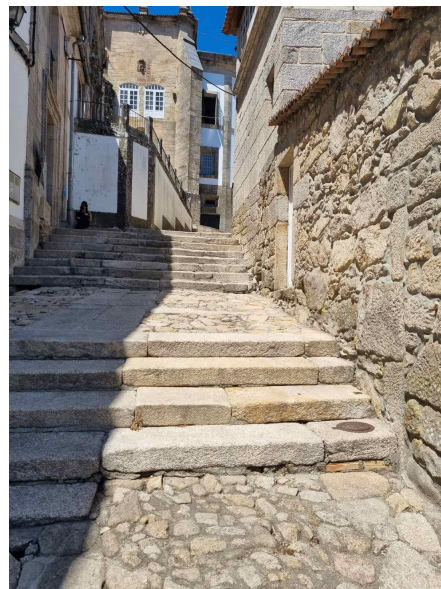
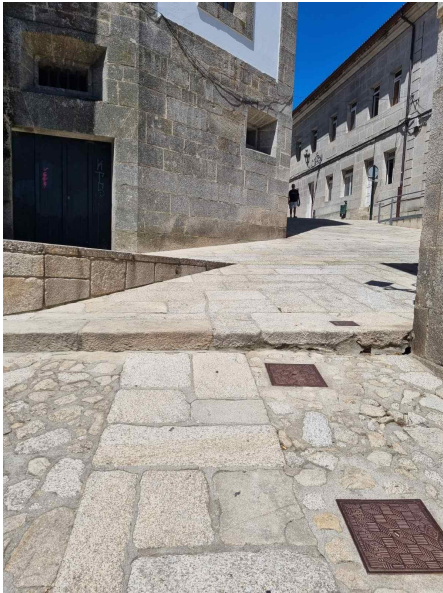
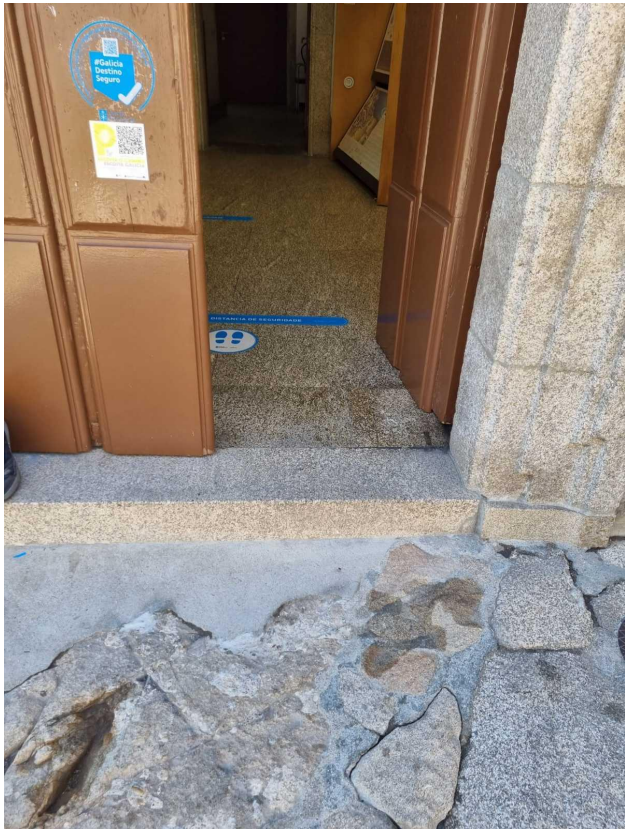
| EVALUATION     |   | COMMENTS  |
|----------------|---|---|
| ACCESSIBLE     | — | To access the hostel there is a series of levels one needs to walk down. In addition, right before arriving at the entrance of the building there are four stairs to take. No ramp available. To be noted, the slope's gradient makes it more difficult to have access. |

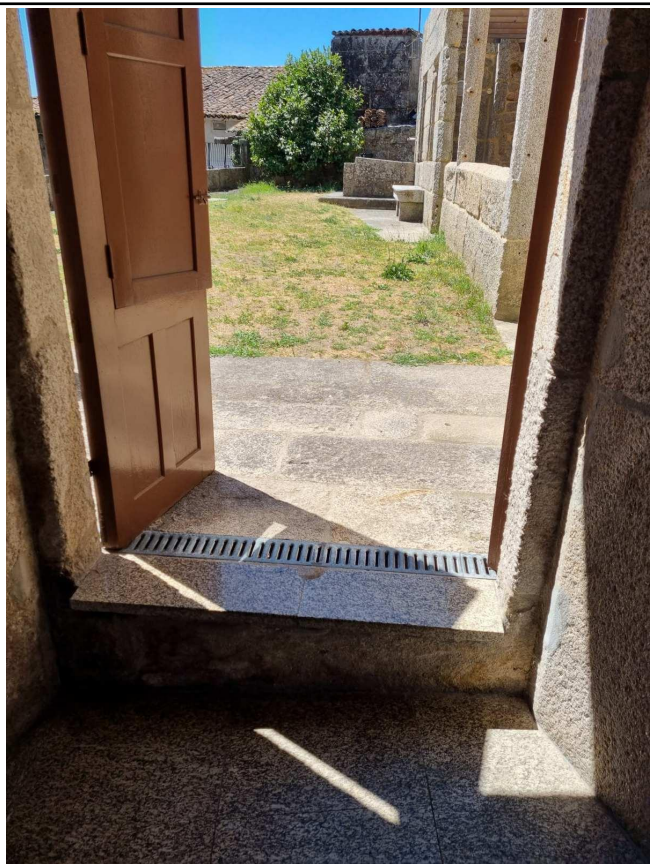
| EVALUATION     |                                     | COMMENTS   |
|----------------|-------------------------------------|--|
| ACCESSIBLE     | <input type="checkbox"/>            | At the main entrance door, there is one stair that would make the passage of a wheelchair impossible without the contribution of other people. |
